P-11403-1

24819

ISSUE-2

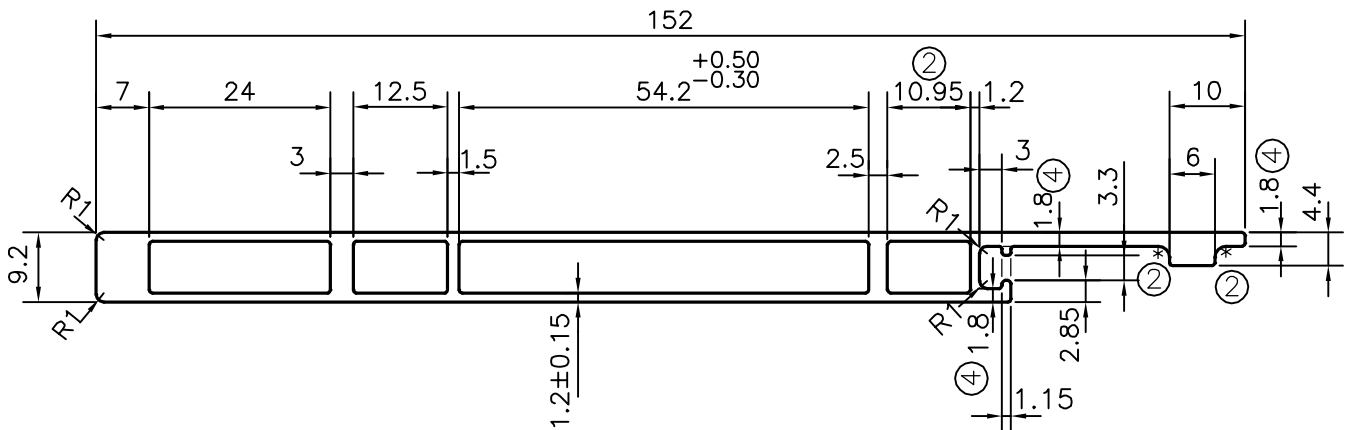
DIMENSION CHANGED FROM 15.1 mm TO 10.95 mm & RADIUS CHANGED 0.4 TO 1.5 mm
 WEIGHT ALSO CHANGED FROM 1.252 TO 1.243 kg/m

THICKNESS CHANGED FROM 1.4 mm TO 1.6 mm
 WEIGHT ALSO CHANGED FROM 1.243 TO 1.257 kg/m

THICKNESS CHANGED FROM 1.6 mm TO 1.8 mm
 WEIGHT ALSO CHANGED FROM 1.257 TO 1.280 kg/m
